NM1 - 10B

JFJ Landfarm LLC
December 12, 2003
Excavation of concrete mixing impoundment

**RE: Surface Waste Management Facility Inspection Report: Permit (NM-01-0010B)
JFJ Landfarm L.L.C.
NW/4 SE/4, Section 2, Township 29 North, Range 12 West, NMPM,
San Juan County, New Mexico**

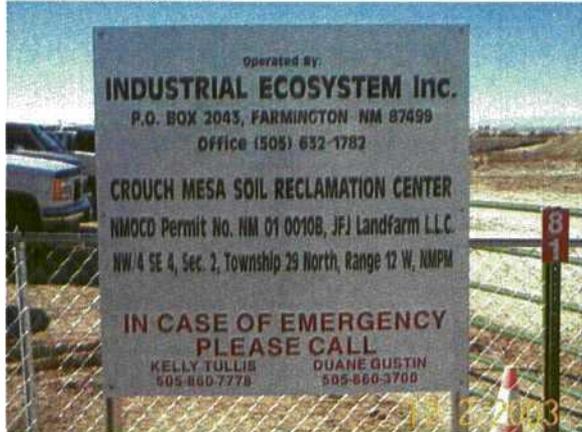
These photos were taken on 12/12/03, note some of the walls disintegrated during excavation, however the west wall was not in good shape before excavation and the entire pad appears to have had a slow leak along the upright and floor joint. The design appears to be flawed in amount and density of re-bar. This pad was constructed without leak detection but had a liner to the edges for leak detection.
Denny Foust, Environmental Engineer

Photo 4. Fuel saddle tank is within an unlined earthen berm. The refueling hose is extended beyond the berm.

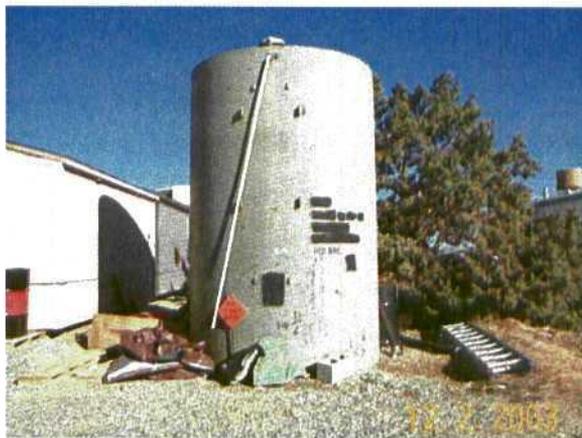
Photo 5. Tank is not labeled as to contents and is not adequately bermed to hold 11/3 the volume of the largest tank.

Photo 6. Concrete mixing containment is has standing liquid. The outside walls are covered and are not accessible for inspections.

Photo 7. Tanks are bermed however the volume of the containment area does not appear to be able to contain 1 1/3 the volume of the largest tank.

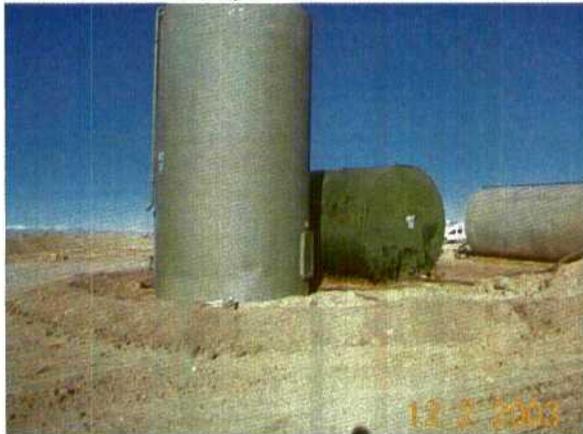
Photo 8. Concrete mixing containment has standing fluids. The wall integrity could not be determined due to the excess contaminated soil piled around the outside of the containment.

Photo 12. Storm water containment along the edge of the landfarm contains a drain pipe that releases storm water runoff directly to a natural drainage.

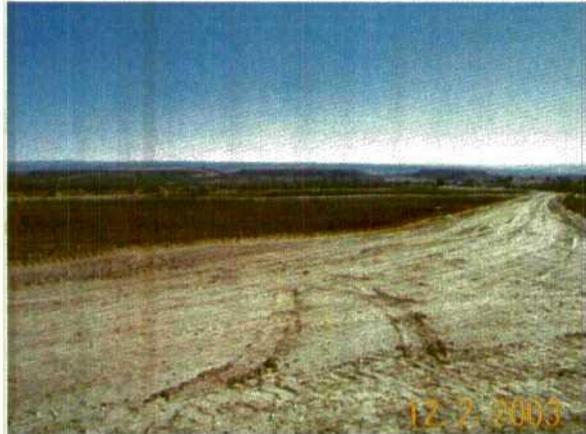
Photo 13. . Drums are stored along a drainage. Drum storage area is not bermed and is not impermeable. Drums are not clearly labeled.

Photo 14. Drums are stored along a drainage. Drums are not labeled and they are not on an impermeable bermed containment. It is not clear which drums are empty and which contain materials.

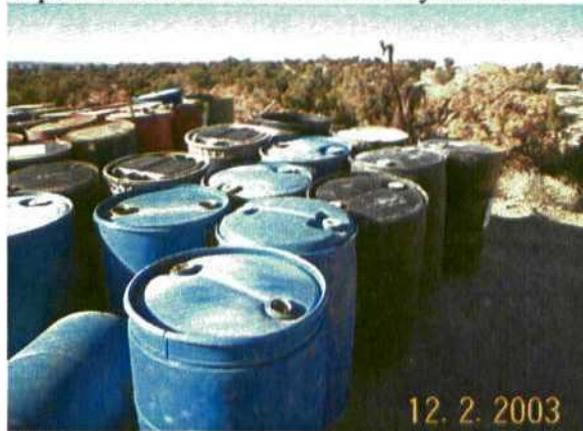
Photo 15. Drums are stored along a drainage. Drums are not labeled and they are not on an impermeable bermed containment.
